**Service Bulletin 521**  
**Issue 1 - January 2015**

<b>Subject: Alternator De-coupler</b>				
<b>Bulletin Number</b>	<b>Models Affected</b>	<b>VIN Range</b>		<b>Markets Affected</b>
521	Tiger Explorer Tiger Explorer XC Trophy SE	From	683888	All
		To	694924

- Alternator de-coupler
- Alternator Wrench T3880602
- 8 mm Allen key

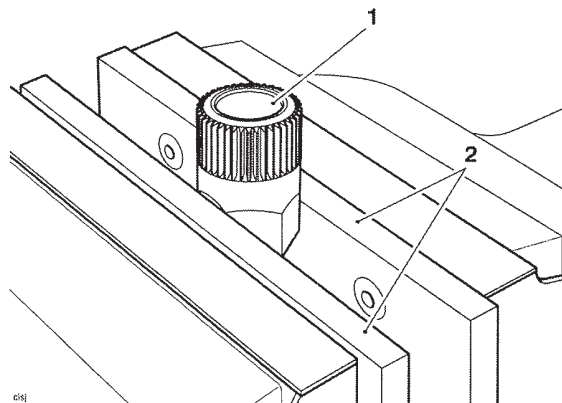
- 
- Prevent the alternator from turning using a spanner on the Alternator Wrench T3880602, and loosen the de-coupler and drive gear assembly nut using an 8 mm Allen key.

1. De-coupler  
2. M4 screws (four shown)

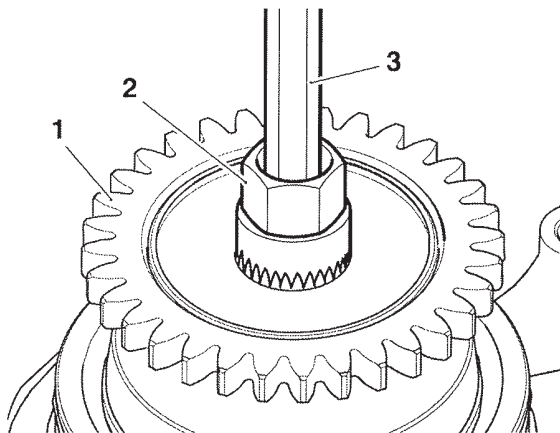
8. Fit the alternator de-coupler to the service tool with the six M4 screws facing upwards.

9. Tighten the drive gear to de-coupler M4 screws to **3 Nm**.  
10. Remove the alternator de-coupler and service tool from the vice.  
11. Fit the de-coupler to the alternator and fit a new nut.  
12. Fit the Alternator Wrench T3880602 to the splines of the alternator de-coupler and drive gear assembly.  
13. Prevent the alternator from turning using a spanner on the Alternator Wrench T3880602 and tighten the new nut to **45 Nm**.
